FINAL PLAT OF
"FIRST ADDITION TO BENTLEY FARMS"
SEDGWICK COUNTY, KANSAS
IN THE NE 1/4 OF SECTION 19, T25S, R1W OF THE 6TH P.M.

RE: S/D 99-61 -- Revised Final Plat of FIRST ADDITION TO BENTLEY FARMS ADDITION

RE: S/D 99-61 -- Revised Final Plat of FIRST ADDITION TO BENTLEY FARMS ADDITION

CASE NUMBER: S/D 99-61 -- FIRST ADDITION TO BENTLEY FARMS

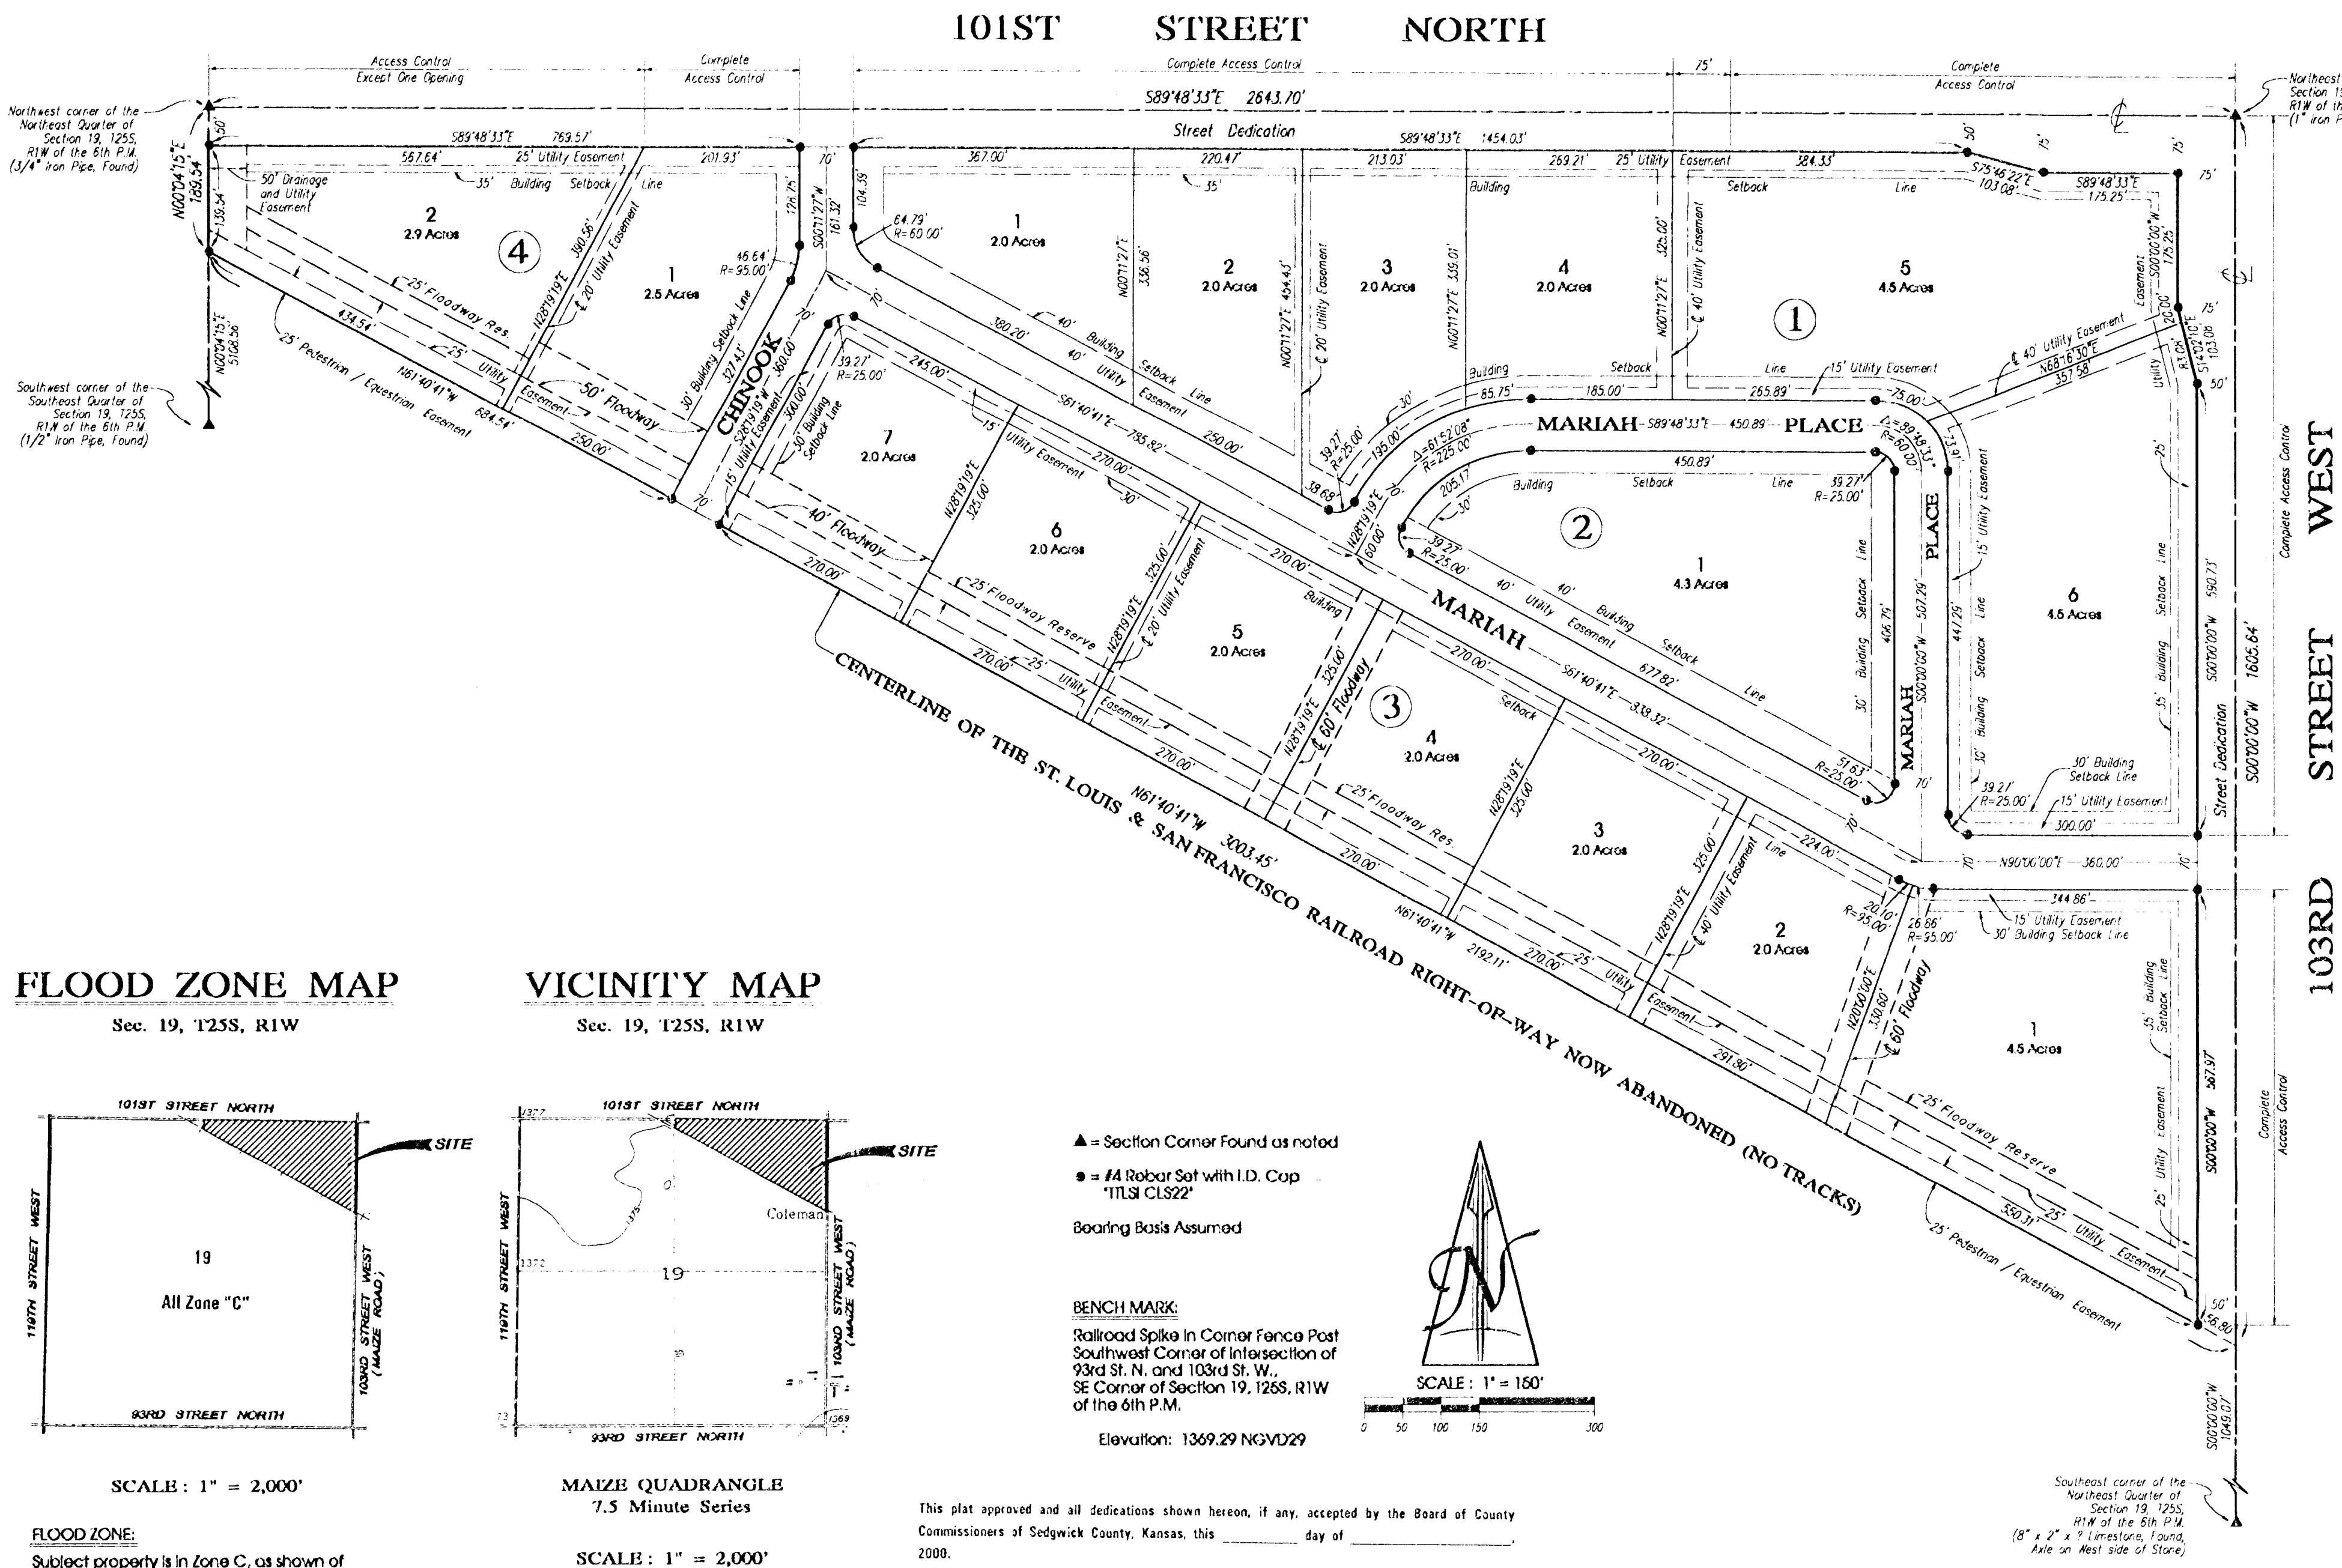
- C. **County Engineering** needs to comment on the status of the applicant's drainage plan. **The drainage plan should include calculations and contours, and denote elevation of existing drainage structures. The proposed drainage detention appears to have no flow outlets.**

- D. **County Engineering** needs to comment on the access controls. **Complete access control is required along 103^d St. West for Lot 5, Block 1 at the intersection. This lot may have one opening along 101st St. North to be located within the west 75 feet of the property.**

- E. **County Fire** needs to approve street names for the proposed interior streets. **County Fire has approved the names Mariah (for the through street), Mariah Place for the loop street, and Chinook for the connection to the southwest.**

- H. The instrument submitted establishing the Derby Oil pipeline appears to indicate that the pipeline is encumbering this plat. If so, it shall be shown and subject to the standard pipeline conditions.

- Q. The representatives from the utility companies should be prepared to comment on the need for any additional utility easements to be platted on this property. Southwestern Bell and KGE have requested additional easements which have been denoted on the final plat.
- R. The applicant is reminded that a disk shall be submitted with the final plat tracing to the Planning Department detailing this plat in digital format in Release 13 version of AutoCAD. This will be used by the City and County GIS Department.
- S. County Engineering has requested a 25 foot utility easement adjoining a 25 foot pedestrian easement at the southwestern line of the plat.

The final plat has denoted the requested access controls.

The final plat has denoted the requested street names.

The requested utility easement has been platted.
